Proposal for SAS 2.1 Specification to Enable Support for Active Cables

Revision 12

QUELLAN

January 8, 2009

Figure 98 — Mini SAS 4x active cable plug connector that attaches to an enclosure out port

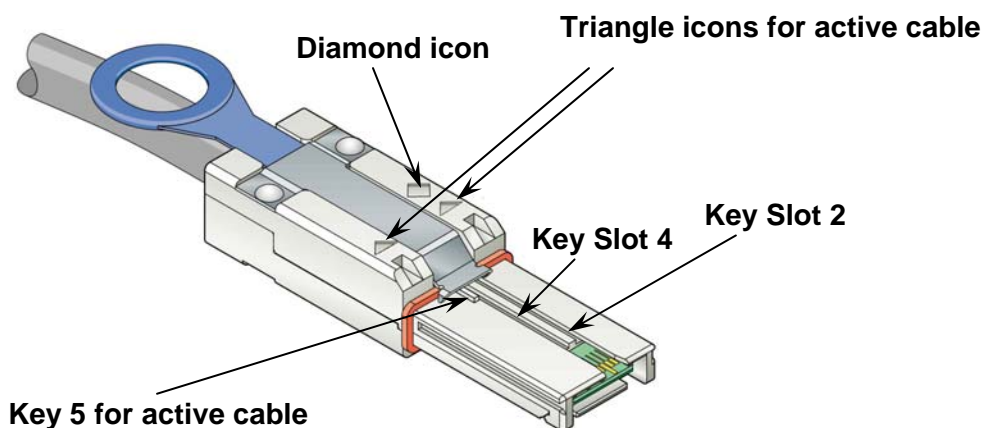
- *Added details of new keying scheme incorporating blocking key in position 5 on the plug and key slots 3 and 5 on receptacle. Updated Figure 98, Table 58 and Table 59 accordingly, added figures 99-101.*
- *Changed the wording in second paragraph of 5.2.7.2.2.1 and second paragraph of 5.2.7.2.2.2 to describe the keying scheme.*
- *Changed the wording of 5.2.7.3.4 from*
“The active cable power supply shall have protection against the connection of the Vcc pin to ground or over-current loading, and shall limit the output current when the supply voltage drops below 2.3 V.”
to
“The active cable power supply shall have protection against the connection of the Vcc pin to ground or over-current loading.”

- *Changed details of active plug keying scheme to differentiate between plugs attaching to enclosure in and enclosure out ports. Updated Figure 98, Table 58 and Table 59 accordingly, added Figure 99, renumbered subsequent figures to be 100-102.*

Figure 98 shows an active mini SAS 4x cable plug connector that attaches to an enclosure out or universal port:
